RE: DRAINAGE EASEMENT IN CASA GRANDE MANOR

Re: Drainage Easement Variance Request Between Lot 22 and 23,
Block C, Lillian Place, Casa Grande Manor

TO: Q. R. KIELICH, ASSISTANT CITY ENGINEER - DESIGN
ATTN: K. LAWS
FROM: R. A. FOSNAUGH, TRAFFIC ENGINEER *RAF*
SUBJECT: CASA GRANDE MANOR DRAINAGE EASEMENT IMPROVEMENTS

Re: Channel Design
Casa Grande Manor
Albuquerque, New Mexico

SITE PLAN

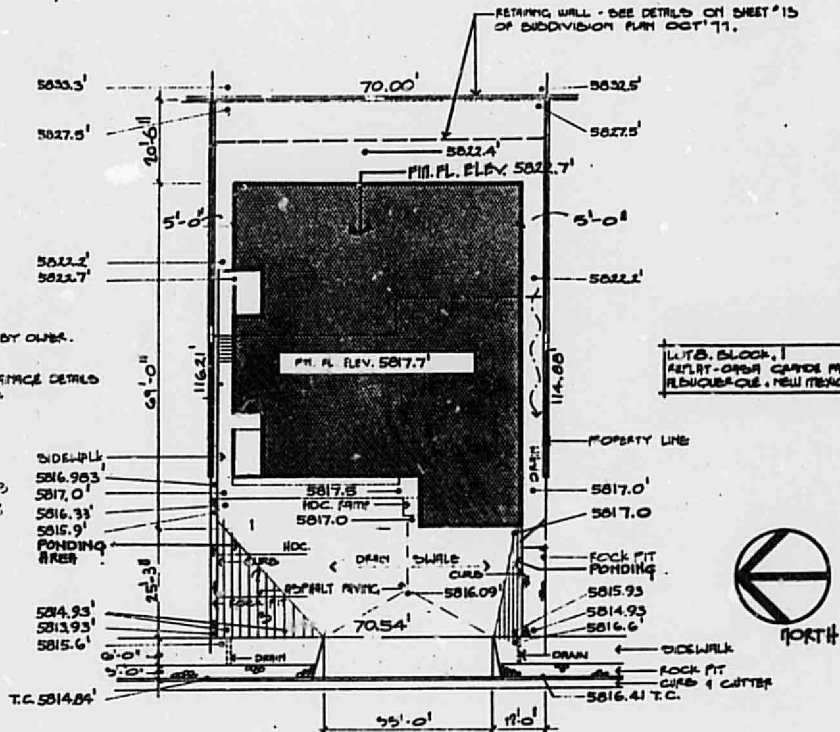
Enclosed is a sketch of said lot showing the existing dwelling and the improvements to be made along the east boundary line.

As Construction Superintendent of Burnside Enterprises and future owner of said lot, I hereby guarantee that these improvements are under construction at this time and will be complete within the near future.

CALCULATIONS

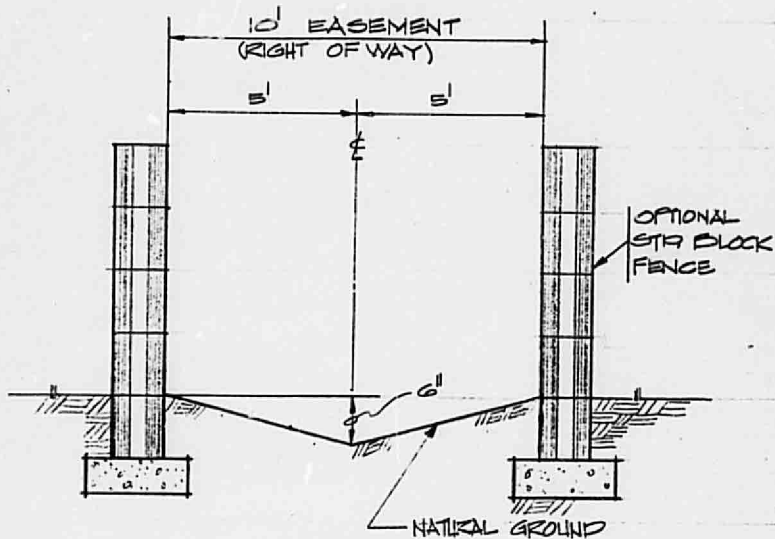
This letter will request a reduction in the storm drain easement width from the platted 20' to 10'. The decrease will be accomplished by moving the northerly right-of-way line 10' toward the south. This will increase the size of Lot 22.

A field inspection of the site indicates that upstream property is designed to be self contained or ponded. A maximum of one acre would drain into this right-of-way. I also enclose a typical detail of the storm drain channel for your approval.
